UNITED STATES PATENT AND TRADEMARK OFFICE

APPLICATION NO.	FILING DATE	FIRST NAMED INVENTOR	ATTORNEY DOCKET NO.	CONFIRMATION NO.
10/527,809	11/09/2005	Hiroshi Ichikawa	52433/789	8919
26646 7590 06/24/2009 KENYON & KENYON LLP ONE BROADWAY NEW YORK, NY 10004				
EXAMINER				
MCGUTHRY BANKS, TIMA MICHELE				
ART UNIT		PAPER NUMBER		
1793				
MAIL DATE		DELIVERY MODE		
06/24/2009		PAPER

Office Action Summary

Ibaraki et al teaches a method for reducing metal oxide in a reducing furnace (abstract) as shown in FIG. 1:

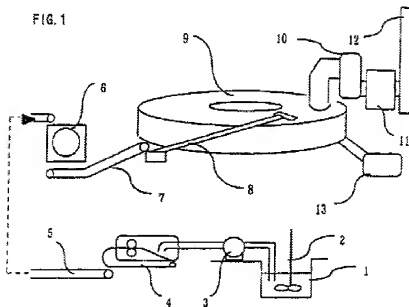
The metal oxides come from a powdery raw material including EAF dust, BOF dusts, mill scale and others (column 7, lines 21-26). The powdery raw material is mixed with water (line 39) and a carbon containing powder (line 18) to make a slurry. The slurry is dehydrated (line 66), and the material is sent to a rotary hearth furnace (abstract) that has a dust collector (column 14, line 98). Regarding Claim 29, the slurry can contain up to 100% water, which is within the claimed range, and the slurry is dehydrated to a moisture content of 16-26% (abstract), which is also within the claimed range. Regarding Claim 30, the powder is mixed with water with a stirrer (column 7, lines 15 and 16). Ibaraki et al is silent with respect to the mixing temperature, which reads on ambient conditions and is within the claimed range. Regarding Claim 31, Ibaraki teaches the powder filling rate of the pellets is about 0.65-0.75 (column 9, lines 29 and 30), which reads on a porosity of at least 35%. The pellets are fed to the rotary hearth furnace. Regarding Claim 32, 16-26% moisture (abstract) is within the claimed range. The article has a thickness or diameter of 30 mm or less (Claim 6) which overlaps the claimed range. Regarding Claim 33, Ibaraki et al teaches that the amount of fixed carbon contained in the shaped articles is 1.5 times or less than the molar number of fixed carbon figured out on the assumption that it reacts with oxygen combined with iron oxide to produce carbon monoxide (column 12, lines 39-42). An example of furnace temperature is 1210 °C and the time is 15 minutes (column 15, lines 41-44). It would have been obvious to one of ordinary skill in the art at the time the invention was made that Ibaraki et al reads on the claimed ratio of molar oxygen and carbon, since a particular parameter must first be recognized as a result-effective variable, i.e., a variable which achieves a recognized result, before the determination of the optimum or workable ranges of said variable might be characterized as routine experimentation; therefore a *prima facie* case

of obviousness exists. See MPEP § 2144.05 II B. Regarding Claim 35, the raw material includes EAF dust, which is steelmaking dust. However, Ibaraki et al does not teach alkali and halogen contents, solubilizing alkali salts, producing a slurry with a pH of 7-11.5, providing a dehydrated material enriched in zinc and/or lead or a waste heat boiler and an air preheater.
